TOWN OF MOUNTAIN VILLAGE REGULAR DESIGN REVIEW BOARD MEETING AGENDA THURSDAY MAY 4, 2023 10:00 AM

5.	10:26	45	Perez/ Applicant	Quasi-Judicial	Consideration of a Design Review: Initial Architecture and Site Review for a single-family home on Lot 391, 142 AJ Drive, Pursuant to CDC Section 17.4.11. This item was continued from the March 30, 2023 regular DRB meeting

AGENDA ITEM 5 PLANNING & DEVELOPMENT SERVICE PLANNING DIVISON

ALPER WILLIAMS RESIDENCE + ACCESSORY DWELLING UNIT

Figure 4: Slope Map Exhibit

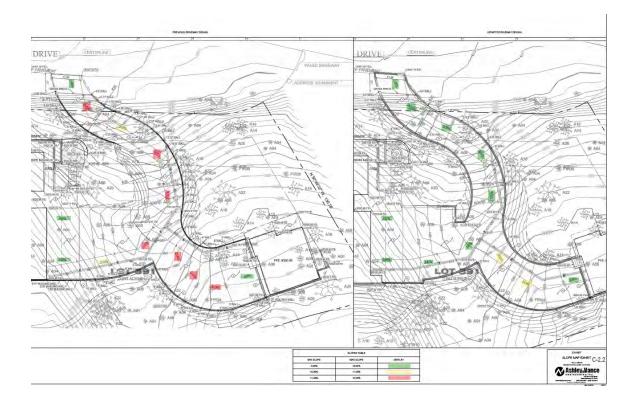
Staff: The applicant revised their application materials to address the grading of the driveway and to indicate updated grade percentages with driveway dimensions, shown on Sheet C2.1. At the previous DRB meetings, the Board expressed concerns relating to the grade of the driveway. The applicant has indicated that the location of the driveway is meant to prevent any right of way issues on the lot and to minimize the slope of the driveway entrance. The maximum proposed grade is 10.51 percent, which exceeds the allowable 8 percent. The section of driveway at 10.51% grade is a short transitional section connecting the ADU driveway to the main section of driveway. Otherwise, the driveway is primarily below 10% grade. The proposed driveway also exceeds the allowable 5 percent grade within 20 feet from the edge of the public roadway, which will require a design variation approval from DRB. The applicant has indicated that they feel a design variation is appropriate given the extreme grade of the site.

Figure 4 below illustrates the previous and revised driveway and its associated grades. Areas of grade above 11% are indicated in red, areas with a grade between 10-11% are indicated in yellow, and areas with a grade below 10% are indicated in green.

The applicant has updated materials to show the driveway width, which varies at the narrowest sections between 16' and 17'. This meets the 12' requirement for driveways. The DRB has previously discussed the possibility of a snowmelt system, although the applicant has indicated that they are trying to avoid a snowmelt system due to the length of the driveway and that adding snowmelt will conflict with the Town's sustainability goals. The DRB should discuss if the revised driveway plan provides adequate transitions for winter driving.

Figure 5: Updated Construction Mitigation Plan

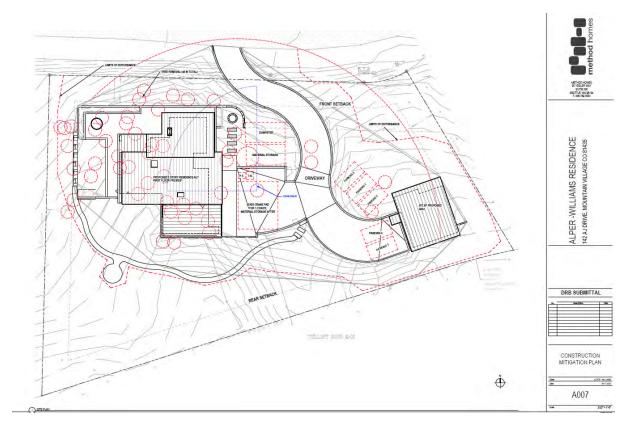
Staff: The applicant provided an updated construction mitigation plan on Sheet A007. The updated plan shows the required dumpster, material storage, bear proof trash and recycling, and port-a-toilet.

The revised Parking Plan indicates two parking spots on the driveway, and three in the yard. The spots located in the driveway will not be available for use until the initial stages of construction are complete. The applicant will likely need to work with Staff for roadside parking permits until the driveway is created. Also, until the driveway is created, some workers may need to be shuttled to the site from off site.

The construction mitigation plan also includes appropriate silt protection through an Erosion Control Plan on Sheets C5.1 and C5.2. The plan does not show tree protection measures for trees that will remain on site. The plan should be revised to include these requirements prior to final review.

The plan includes a 30' x 30' crane pad on the proposed driveway. The crane is proposed to be on site for 1-2 days and the applicant shall work with Town staff to make sure the crane swing doesn't impede the roadway. The applicant has also updated the plan to show the crane swing radius.
